REMARKS

Applicant's Attorney has requested several changes to the drawings to correct a self-evident error and to improve clarity. In particular, Applicant's Attorney has requested that:

NS-5127

Fig. 15

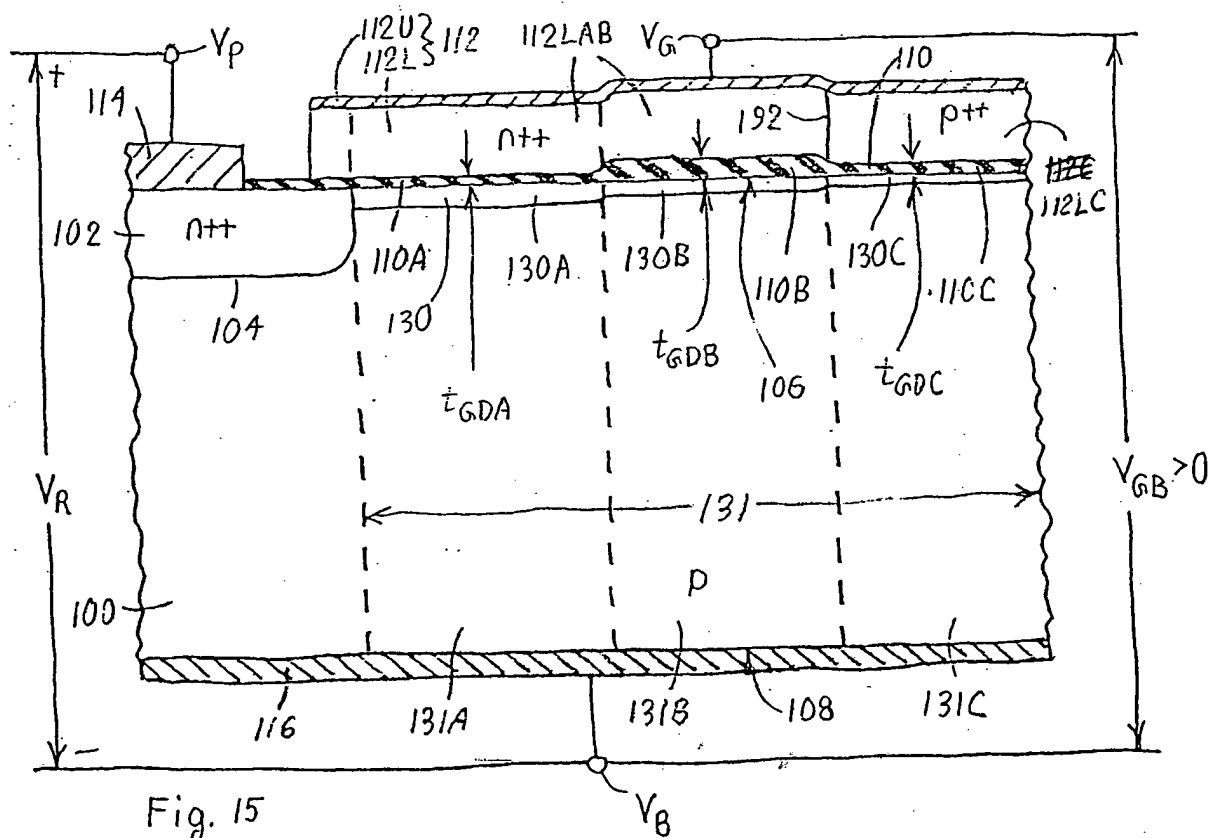
a. Reference symbol "112C" for the p++ lower right-hand gate electrode portion in Fig. 15 be changed to "112LC" in conformity with the disclosure in paragraph 198 of the specification that lower gate electrode layer 112L in Fig. 15 consists of very heavily doped n-type polycrystalline silicon ("polysilicon") gate electrode portion 112LAB and very heavily doped p-type polysilicon gate electrode portion "112LC"; and

Fig. 17

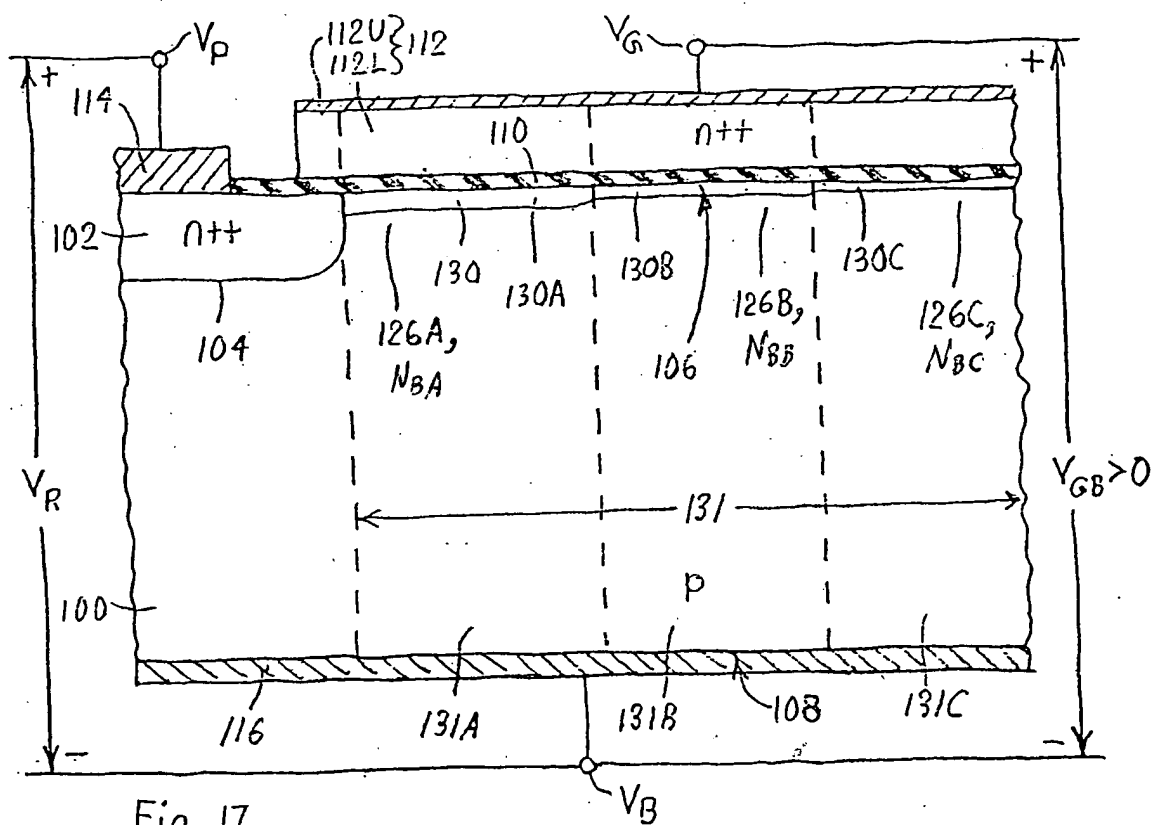
b. Reference symbols "126A", "126B", and "126C" in Fig. 17 be respectively changed to "126A, N_{BA} ", "126B, N_{BB} ", and "126C, N_{BC} " in conformity with the disclosure in paragraph 207 of the specification that portions 126A, 126B, and 126C of surface depletion region 126 have respective different values N_{BA} , N_{BB} , and N_{BC} of average net dopant concentration N_B .
